Access Compliance Report

Public Rights-of-Way (Curb Ramps)

Intersection ID: 2908	Main Street: CORNER_CT	Cross Street: MEADOWVIEW_HILLS_DR	Location: NE
ADA ID: 3999B1D4F9D1	Ramp Type: PerpDiag	Initial Pass/Fail: Fail	Overall Compliance: No
Severity Score: 25			
Codes/Mitigation Info/Possible Solution		Field Measurements/Component Compliance

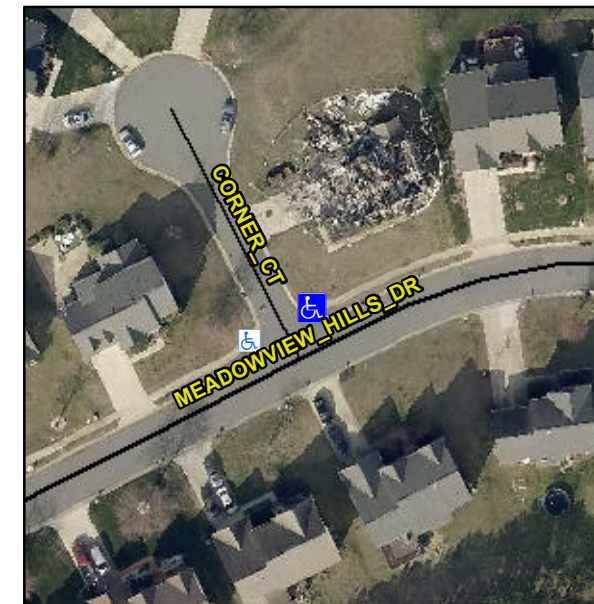
Not Found, R304.2.2, R304.5.3

Compliance	Description	Data	Compliance	Description	Data
N/A	Ramp Length (in)	45.0	No	Ramp Slope (%)	9.4
Yes	Ramp Width (in)	53.0	No	Ramp XSlope (%)	6.9
N/A	Flare Type LT	N/A	N/A	Flare Type RT	N/A
N/A	Flare Slope LT (%)	N/A	N/A	Flare Slope RT (%)	N/A
N/A	Flare Traversable LT?	N/A	N/A	Flare Traversable RT?	N/A
N/A	Landing Length (in)	N/A	N/A	DWS Provided?	N/A
N/A	Landing Width (in)	N/A	N/A	DWS Contrast?	N/A
N/A	Landing Slope (%)	N/A	N/A	DWS Length (in)	N/A
N/A	Landing X Slope (%)	N/A	N/A	DWS Full Width?	N/A
N/A	Landing Curb? (Y/N)	N/A	N/A	DWS Offset (in)	N/A
N/A	Shared Landing?	N/A			
N/A	Gutter Ponding?	N/A	N/A	Gutter Slope (%)	N/A
N/A	Gutter Lip Ht (in)	N/A	N/A	Gutter X Slope (%)	N/A
N/A	Painted X Walk1?	No	N/A	Painted X Walk2?	No
	X Walk 1 Direction	To W		X Walk 2 Direction	To S
N/A	X Walk 1 Width (in)	N/A	N/A	X Walk 2 Width (in)	N/A
	X Walk 1 Slope (%)	3.9		X Walk 2 Slope (%)	1.5
	X Walk 1 X Slope (%)	2.7		X Walk 2 X Slope (%)	6.4

N/A	Ramp inside XWalk1?	N/A	N/A	Ramp inside XWalk2?	N/A
	Road Slope (%)	7.7	N/A	Clear Space?	N/A
	Road X Slope (%)	4.9	N/A	Clear Space to XWalk (in)	N/A
N/A	Any Obstructions?	N/A	N/A	Storm Grate/Utility Hazard?	N/A
	Obstruction Type			Storm Grate/Utility Type	
		N/A			N/A
		Yes		Surface Condition? (G/P)	Good

Remove & Replace Curb Ramp With Two New Directional Ramps or Equivalent.
